Subject: USNRC Docket No. 72-1014, TAC L23850
HI-STORM 100 Certificate of Compliance 1014, Proposed Amendment 5

Via e-mail on August 31st (Reference 2), the SFST staff identified an apparent discrepancy in the Proposed Revised FSAR previously submitted in support of Proposed Amendment 5 to the HI-STORM 100 Certificate of Compliance. Holtec has investigated the apparent discrepancy and determined that Table 2.0.1 contained an incorrect maximum stainless steel design temperature. This value was "rolled back" from 1200°F to 950°F in other sections of the FSAR in response to an earlier SFST request (Reference 3), but was inadvertently left in this one table. It was agreed, in a teleconference on September 5th (Reference 4), that this oversight would be corrected. A replacement page is attached (Attachment 1).

Via teleconferences on August 30th and September 6th (References 5 and 6), the SFST staff requested several editorial changes in Appendices A and B to the Proposed Revised Certificate of Compliance. The minor modifications requested include:

**Figure 2.1-1
Fuel Loading Regions - MPC-24**

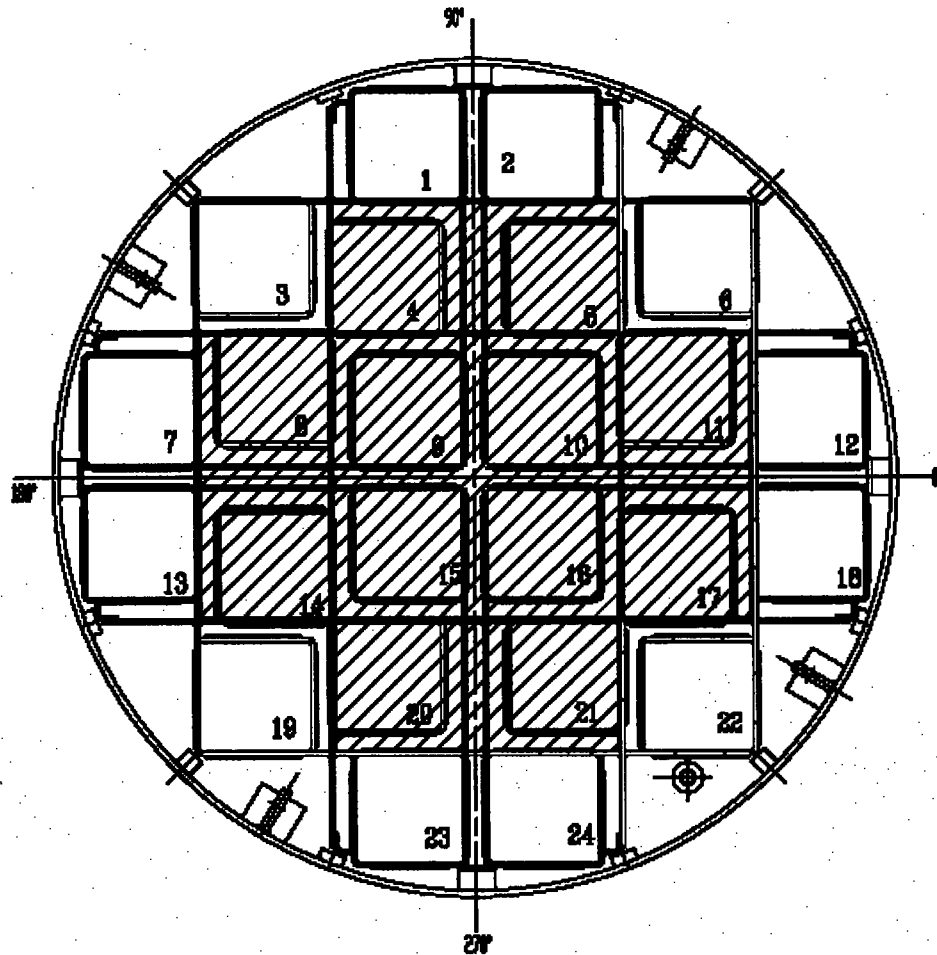
1. Slight rewording to ensure that definitions in both Sections A1.1 and B1.0 are identical
2. Corrections to the Region 1 "hatching" in Figures B2.1-1 and B2.1-2
3. Correction of the title of Section IV of Table B2.1-1
4. Correcting the allowable locations for NSAs in Note 1 in Section V of Table B2.1-1
5. Correction of a typographical error in the equation for q_2 in Section B2.4.2
